Permit Amendment for 14050 Triadelphia Road, Glenelg, MD 20737
Permit # ~~B19002424~~ **B19004373**

We are writing to request a permit amendment for the above reference property. We are requesting an amendment to demo all first floor walls down to decking due water damage caused by poorly flashed fireplace.

OGUNMEFUN RESIDENCE

SITE PLAN

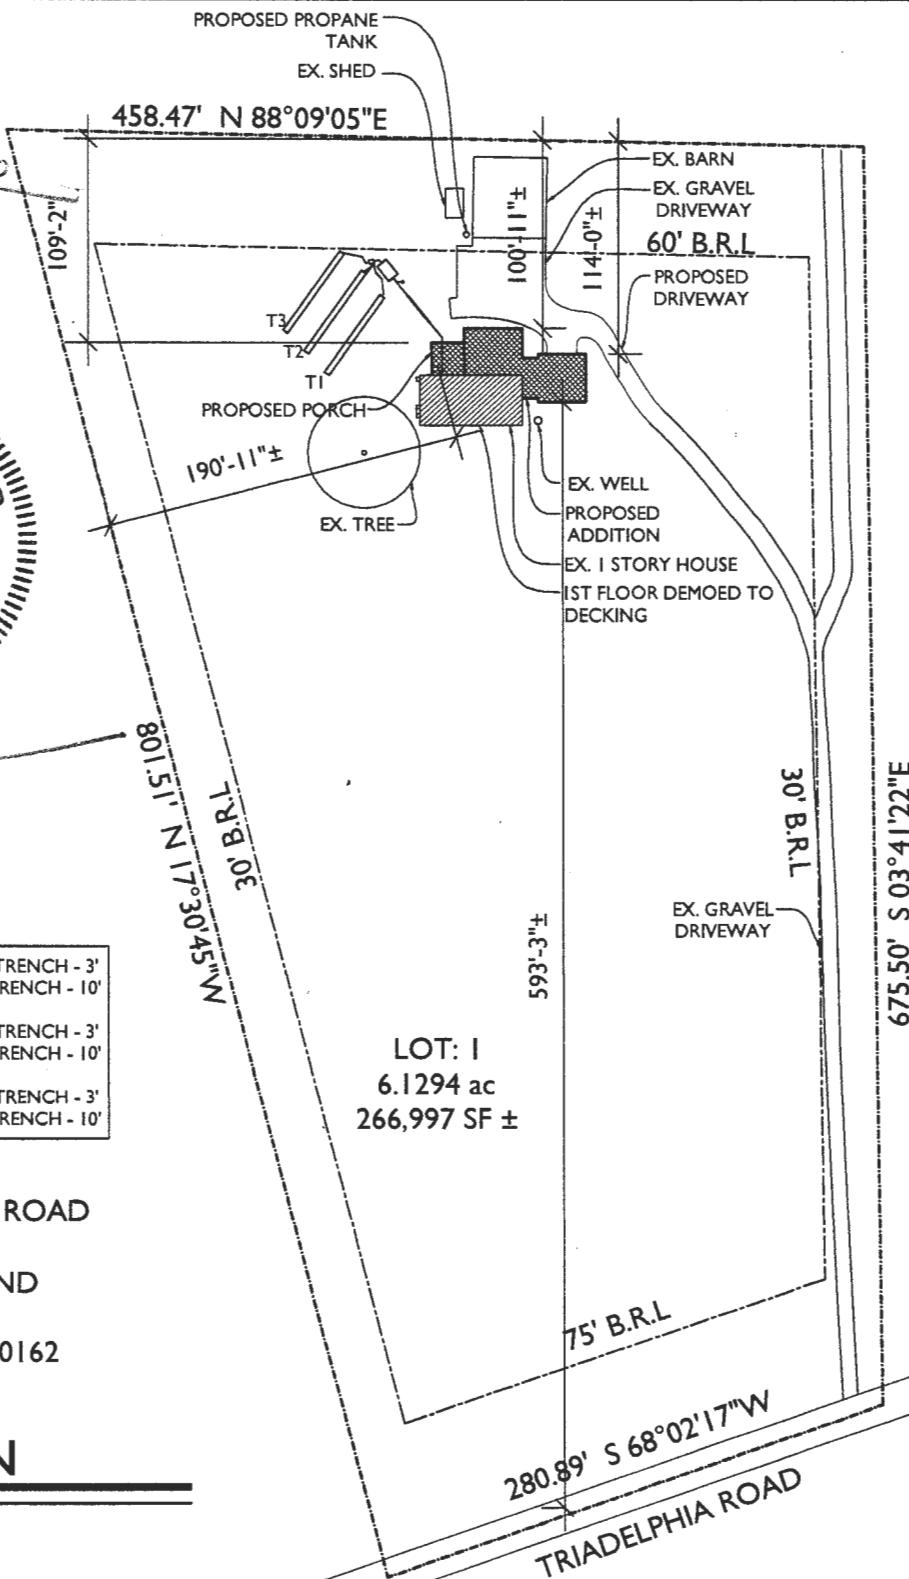
REVISED
 Date: 12-30-19
 Comments: demo
 all walls
 B19004373
